**Solutia Inc.**

**Re: Sauget Sites Area I - May 31, 2000 Unilateral Administrative Order  
Docket No. V-W-99-C-554  
Dead Creek Sediments & Soils Removal / Containment**

- Time Critical Removal Action Work Plan
- Response to Comments - Part 1

**Riser Pipe Details**

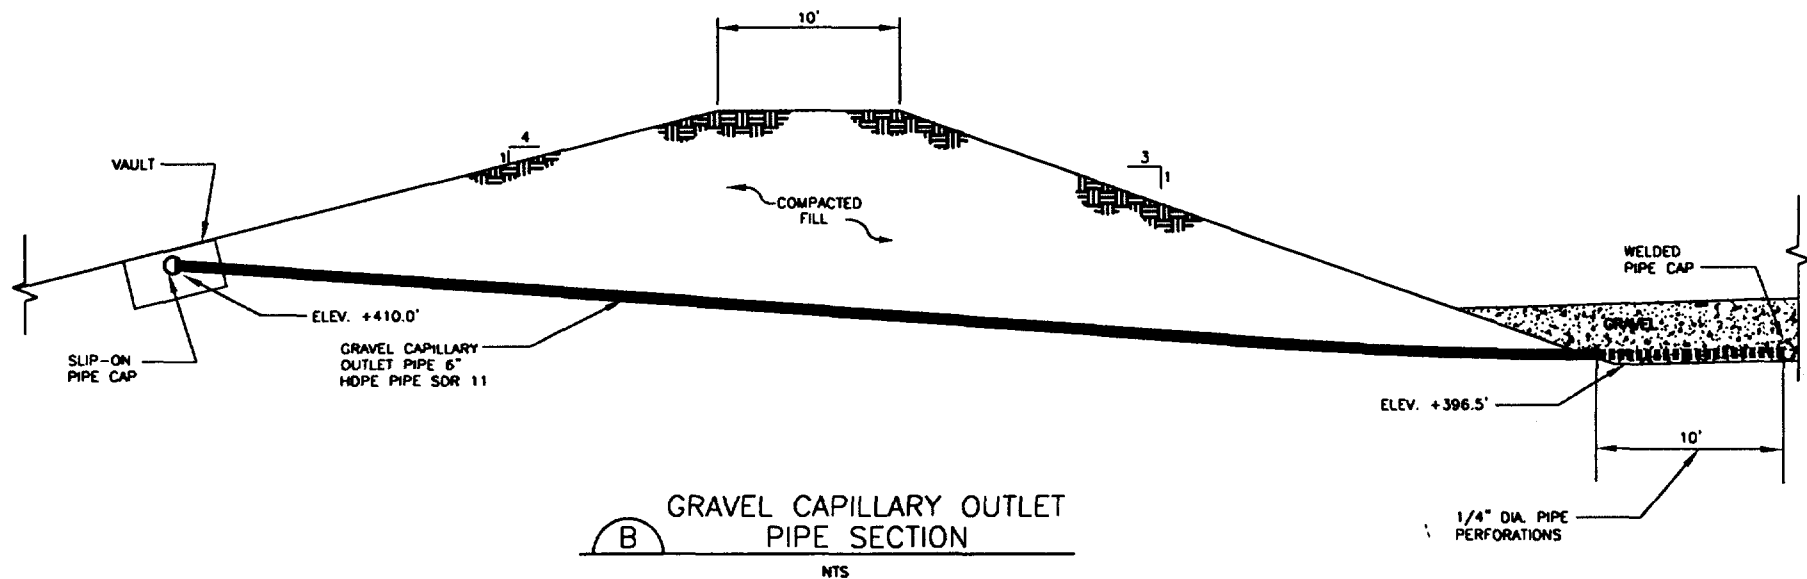
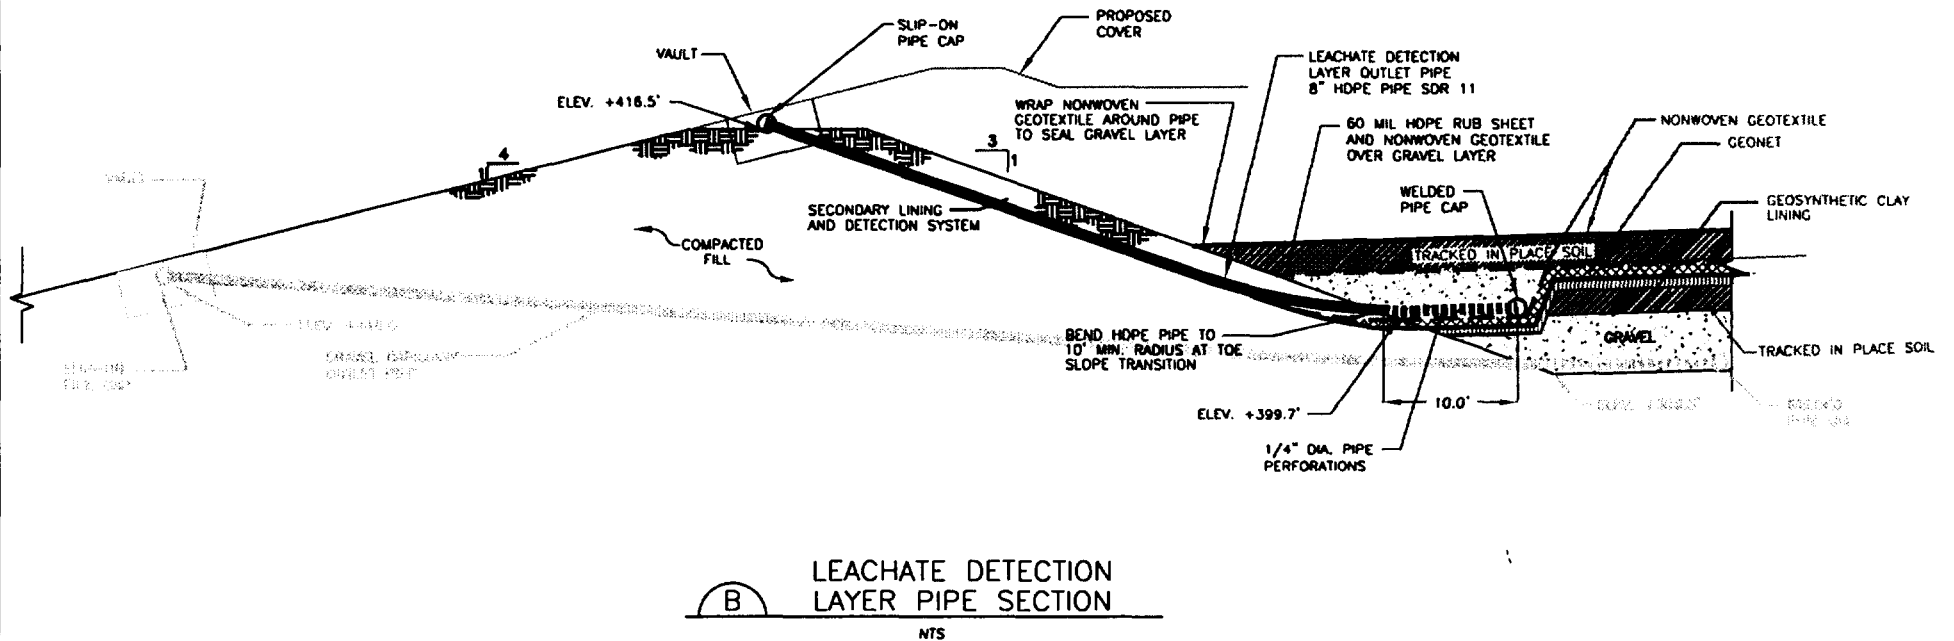
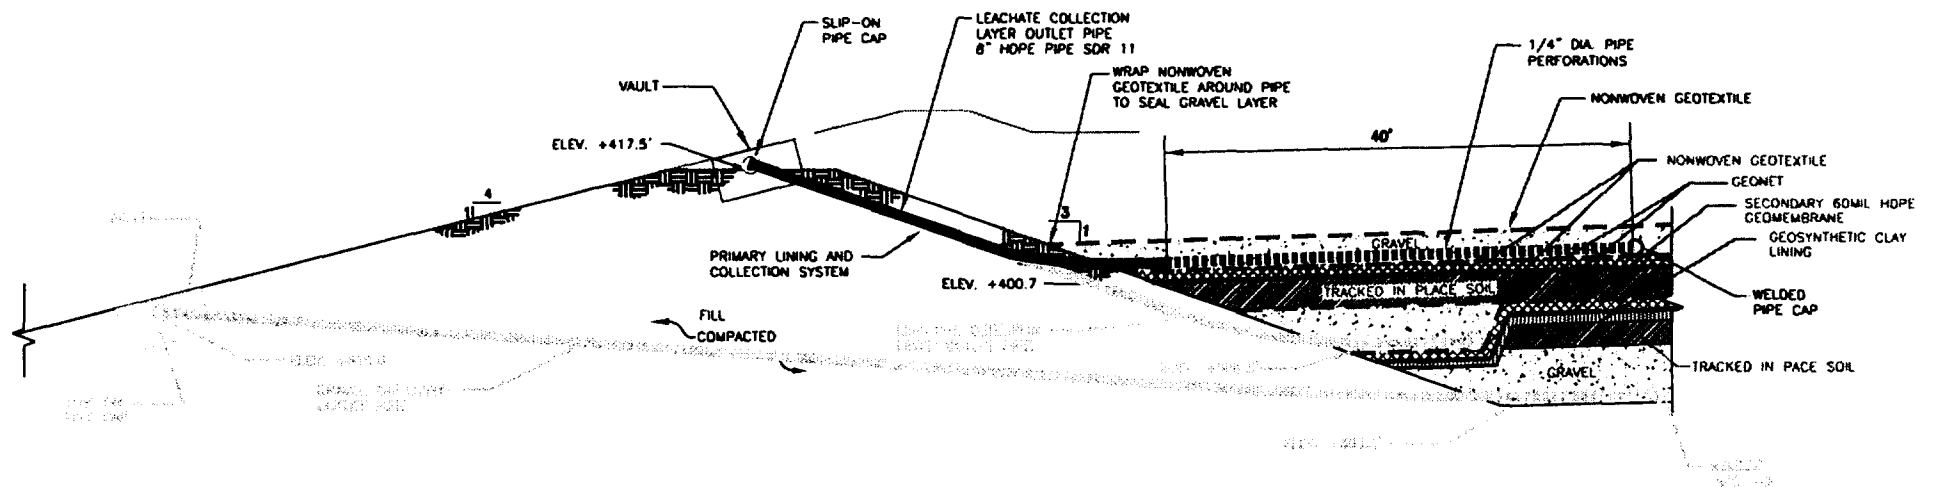
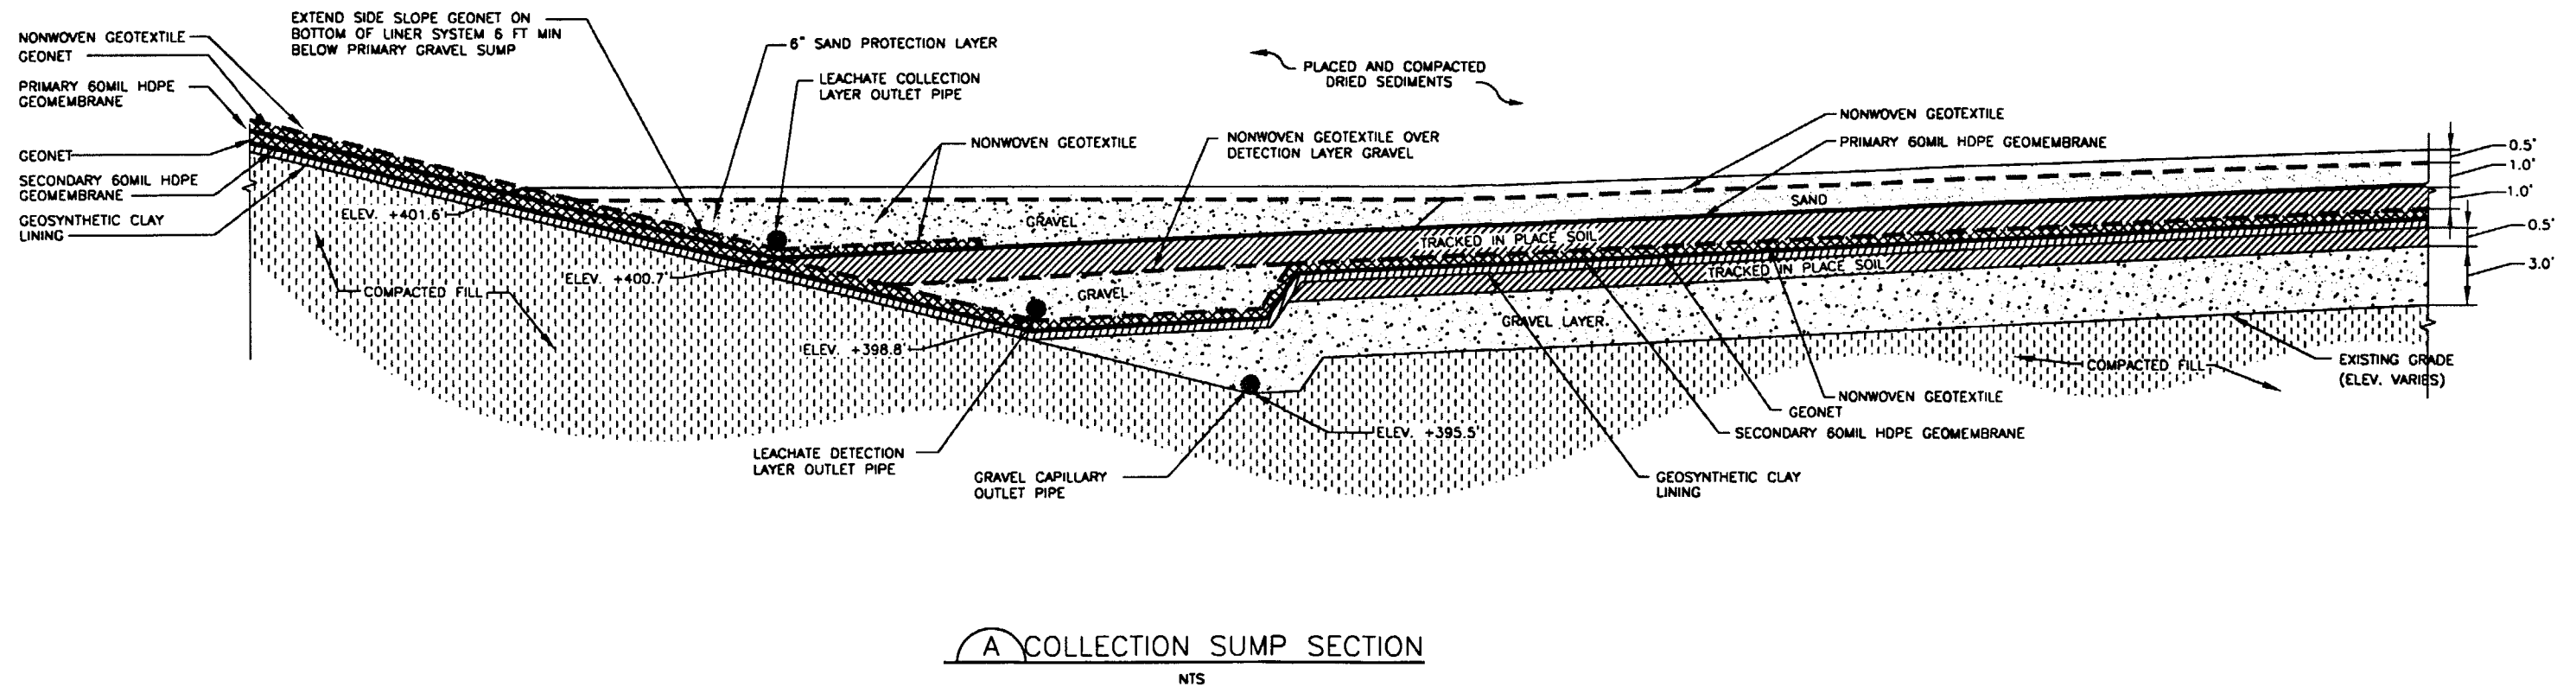
**17. Appendix 7, Figure 4-8 and 4-9:** Please add detail drawings for both the primary and secondary riser which shows a cross section of the sump and riser as the riser angles up the slope to the top of the containment cell.

**Response:** Drawings showing cross sections of the sump and riser as the riser angles up the slope of the containment cell will be prepared revised as indicated below and included in the Figures section of Appendix 7. These drawings are included as Attachment 3 of this response to comments document.

**COVER SYSTEM PLAN**

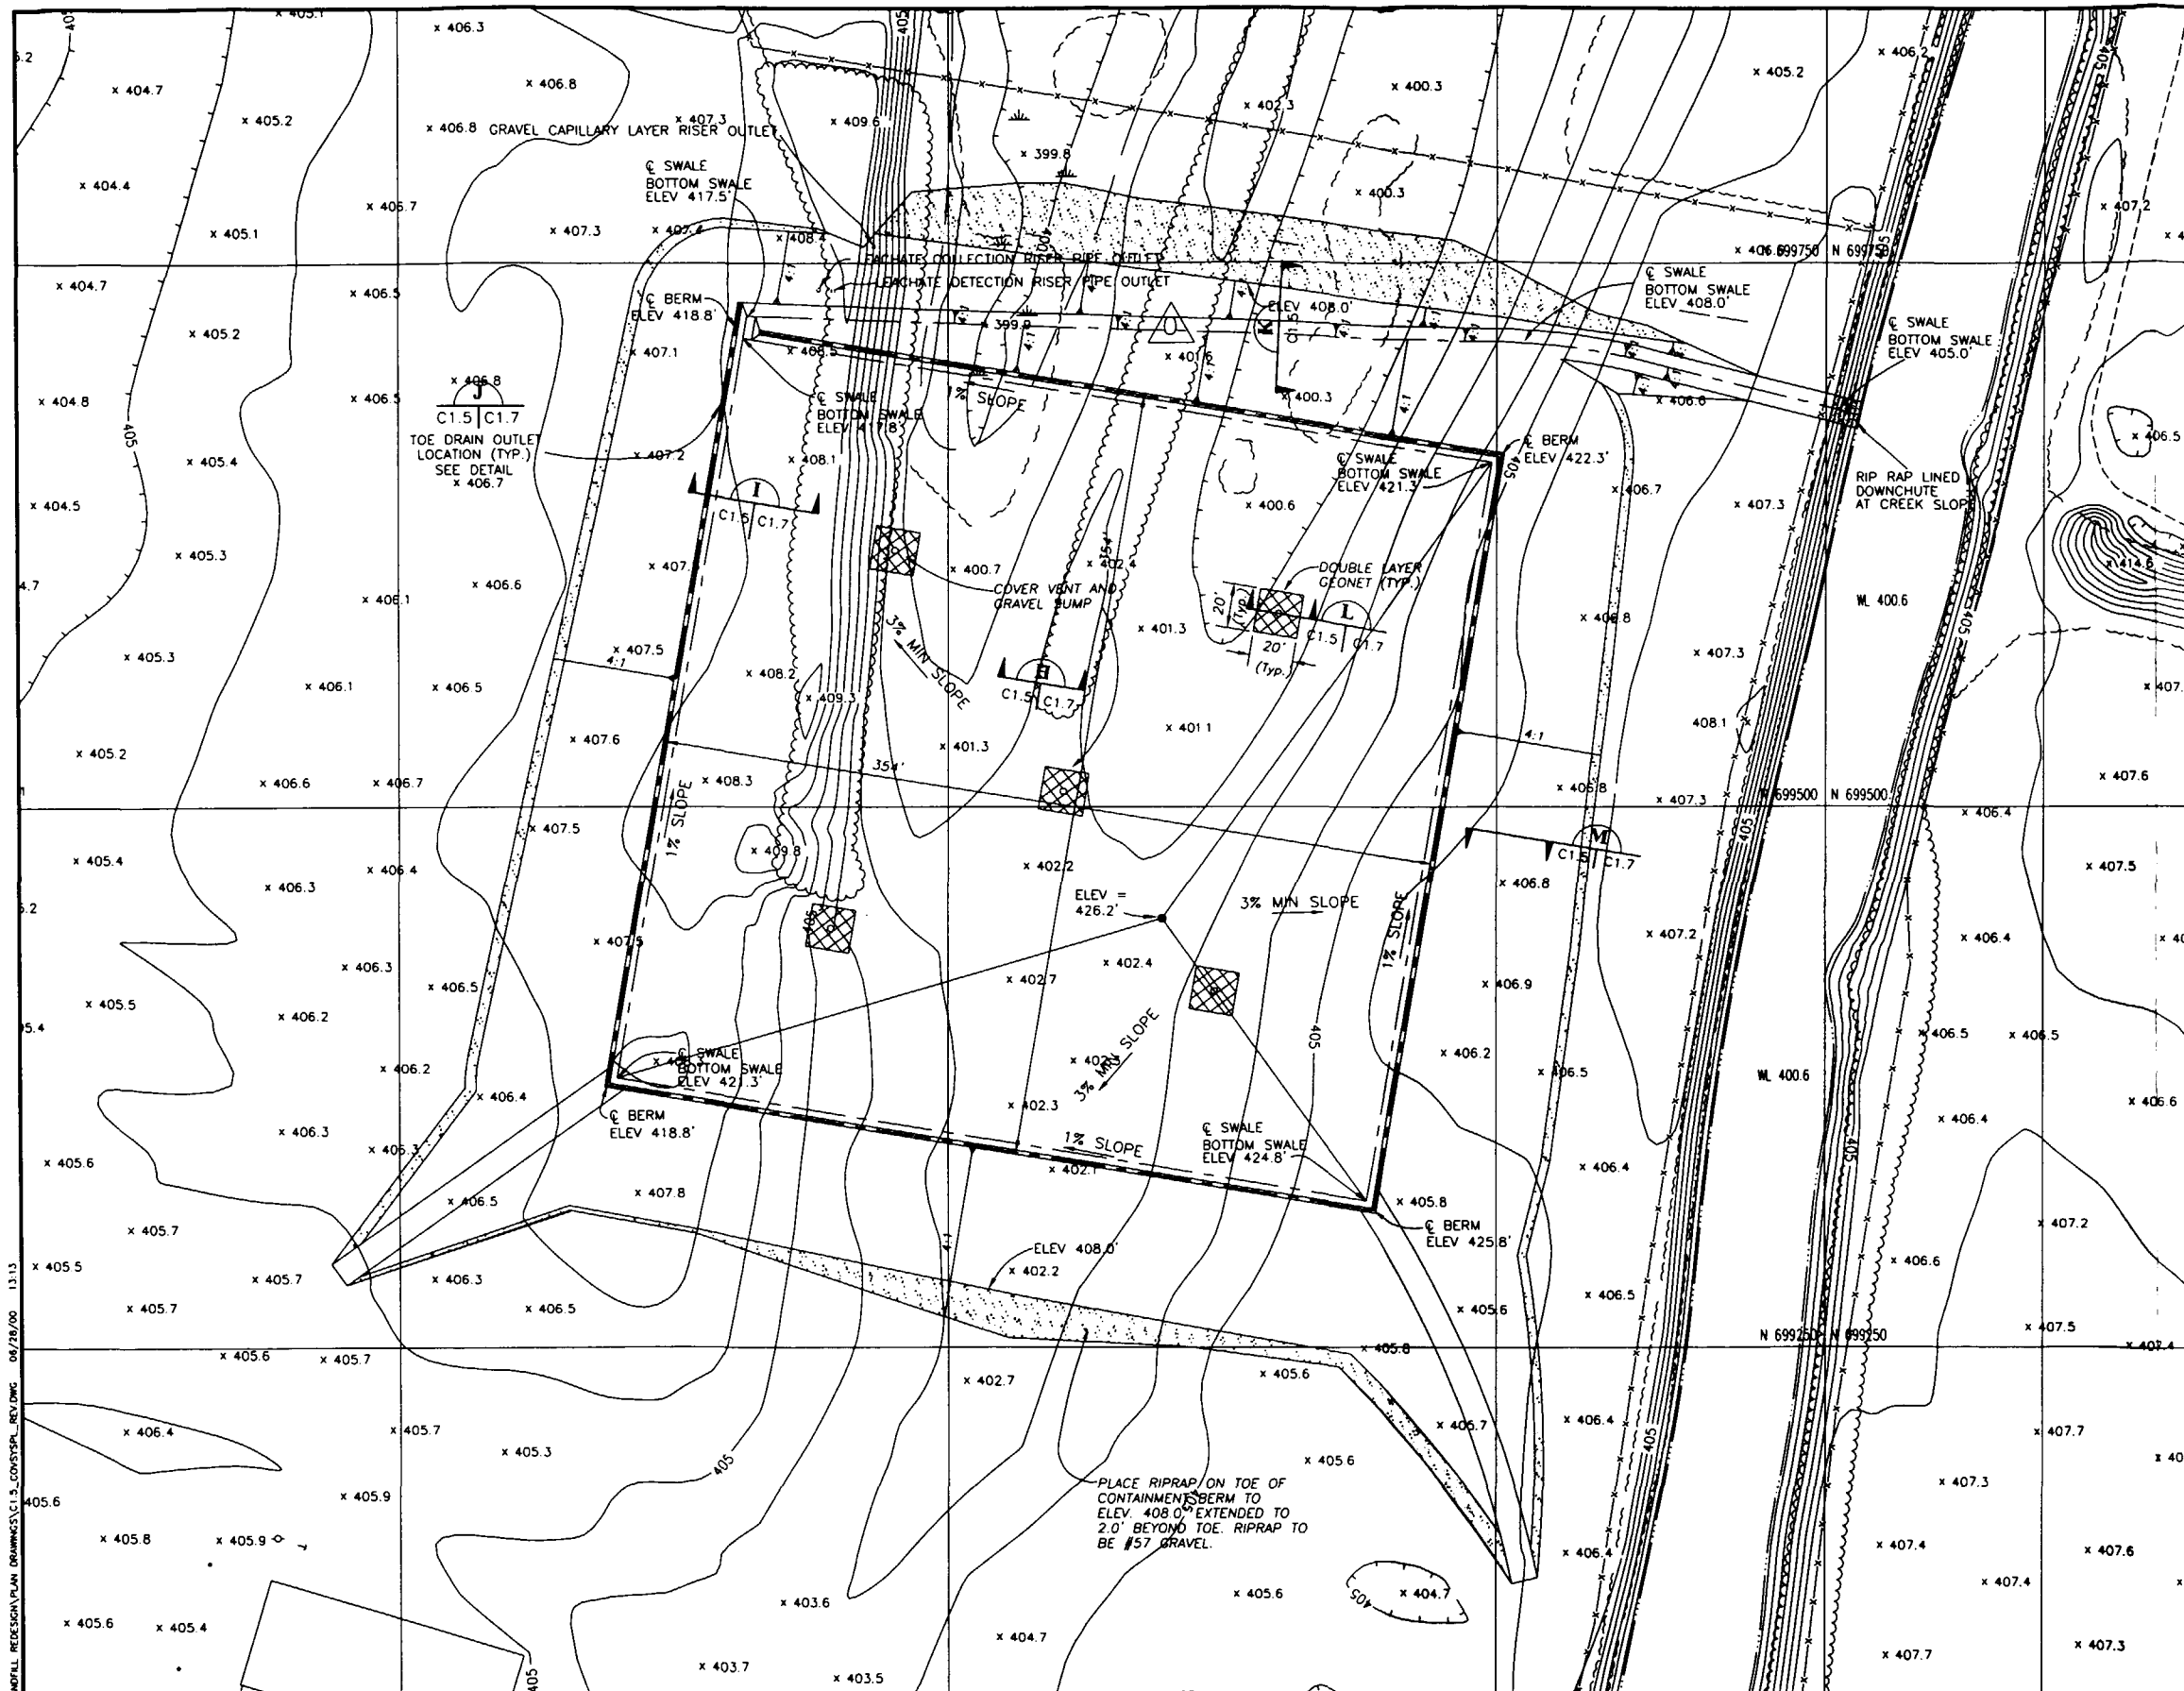
**16. Appendix 7, Section 5, Page 5-5, Subsection 5.4.4:** Where does the storm water flow after its has traveled down the paved downchute and into the stilling basin? It appears from the drawing Cover System Plan, Sheet C1.5 that nothing is contemplated. I think it is best to direct the surface water away from the containment cell and either into Segment B or a storm sewer as soon as possible. Please indicate within the text and if appropriate alter the drawing Cover System Plan, Sheet C1.5.

**Response:** Paragraph 3 of Section 5.4.4 Drainage and Erosion will be modified as follows and included in the Work Plan verbatim:

The downchute and stilling basin are designed to handle 14 cfs peak flow. **A drainage swale will be constructed north of the containment cell to route storm water from the stilling basin to Creek Segment B which will be used to provide the storm water detention required by local and state regulations.** The stormwater calculations for the cover system are provided in Appendix D.
